Agenda Item Number 16

in support of a motion to **APPROVE** the request from Triad Development (owner) represented by Mana Thongvanh (officer) for approval of a preliminary subdivision plat for "Grandview Meadows", located at 4301 Grandview Avenue, to include 34 single-family residential lots on 10.39 acres, and a 0.47 acre "Parcel A" to contain an existing single-family dwelling, subject to the following conditions:

PRELIMINARY PLAT GRANDVIEW MEADOWS

Grandview Meadows - Preliminary Plat - E 43rd St & Grandview Ave Area

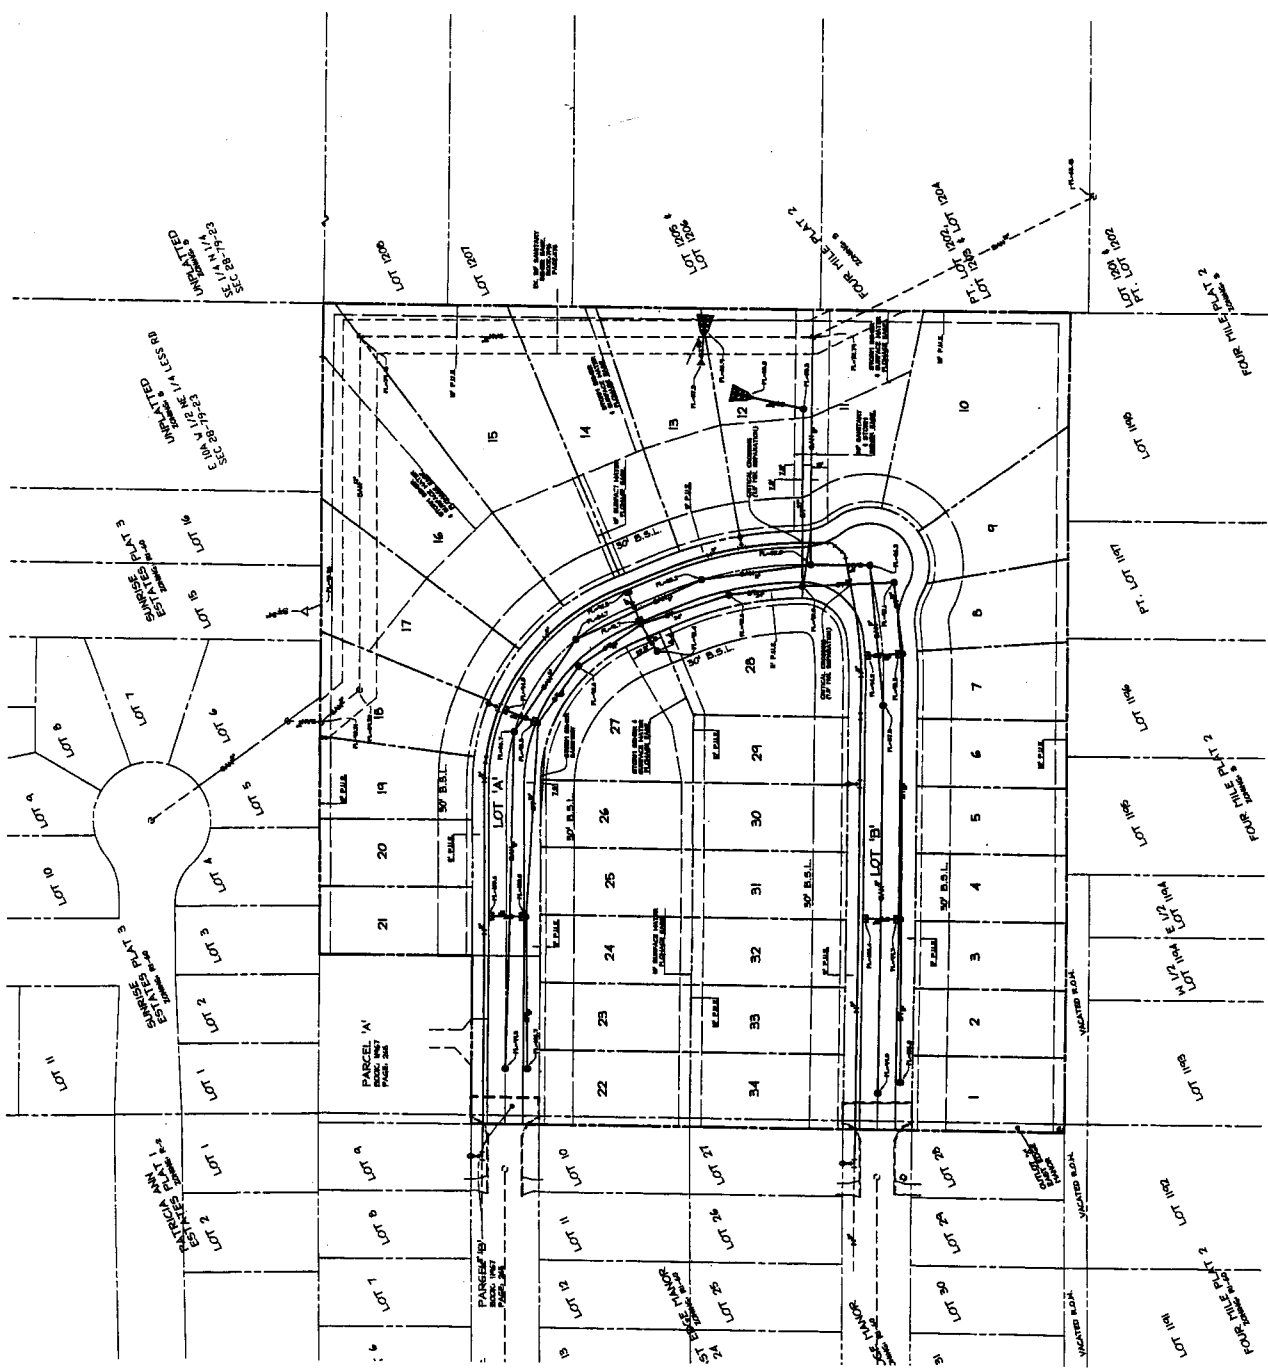
1. **Natural Site Features:** The subject property generally slopes downward to the east and south and is heavily wooded. The plat originally submitted identified the removal of 225 trees due to grading. Including 49 trees that are of a significant species (Ash, Birch & Maple) with a total of 496 caliper inches. The revised plat identifies the removal of 169 trees, including 20 are of a significant species with a total of 176 caliper inches due to grading. The applicant has also identified 21 significant species trees with a total of 245 caliper inches that will likely be removed during home construction. This calculation is based on the assumption that all houses will be constructed at the minimum front yard setback line and will be 45' deep. The applicant has identified 23 significant specie trees with a total of 244 caliper inches that will not be impacted by grading or likely by house construction. The plat includes tree protection notes.

2. **Drainage/Grading:** The submitted preliminary plat shows grading for lot and street improvements as well as storm water management. The design for the plat proposes a combination of surface water flowage easements and storm sewers in the streets. These facilities release into a storm water basin located at the rear of Lots 11 – 16 in the eastern portion of the development. The basin is designed to temporarily hold water from larger storm events and to release it at a limited rate to the east.

Engineering staff has reviewed the soils report and drainage calculations for this plat. The applicant has also submitted an observation and recommendation report for the abandoned coalmine that exists on the site. This report recommends that the area thought to contain the

mineshaft be stripped so sub-grade conditions can be observed and that if a shaft is found it should be capped.

The applicant has submitted additional information identifying the probable mine shaft location along the northern edge of lots 25 and 26 along the right-of-way. This location is based on field observations made by the applicant's consultant team including Cooper Crawford Civil Engineering and Geo Tech a geotechnical engineering firm. Staff concurs with the report and will require the developer to cap the shaft in accordance with the report if the plat is approved.

- 3. Utilities:** The plat indicates that public sanitary sewer will be accessed in the southeast portion of the site from a 12" main. 8" sanitary sewer mains generally follow the proposed street network.

An 8" water main will be extended from the Des Moines Waterworks public water mains located in Grandview Avenue and Morton Avenue to the west along the proposed streets.

- 4. Traffic/Street System:** The subject site is located at the easterly terminus of both Grandview Avenue and Morton Avenue. These streets were constructed with temporary hammerhead turnarounds and designed to be extended in the future. The City's Traffic and Transportation staff have determined that the existing Grandview and Morton Avenues, which extend 560' east from East 42nd Street, can handle the additional traffic generated by the proposed single-family residential development. The submitted plat proposes connecting these two streets with a loop design.

There is a large undeveloped parcel to the northeast of the site that borders the eastern 170' of the subject property's north property line. Staff believes it is not prudent to require the developer to extend a street to the northeast due to existing grades. There are other opportunities to provide connectivity in the general area and access to the adjoining property. The additional grading required would increase the number of trees that would need to be removed. This area also accommodates storm water flowage from the developments to the northwest. Existing rural residential development prohibits the extension of streets to the south or east.

1. Provision of one 1½"-caliper street tree, one ornamental tree in the front yard and one 3"-caliper tree in the rear yard per lot.
2. Compliance with all comments from the administrative review by the Permit and Development Center.
3. Provision of a note on the final plat indicating the presence and general location of the abandoned mine shaft. The vertical mineshaft was filled in years ago.
4. Provision that at the time of final plat a representative return to the Commission to explain how the abandoned mineshaft was compacted or capped to prevent subsidence.
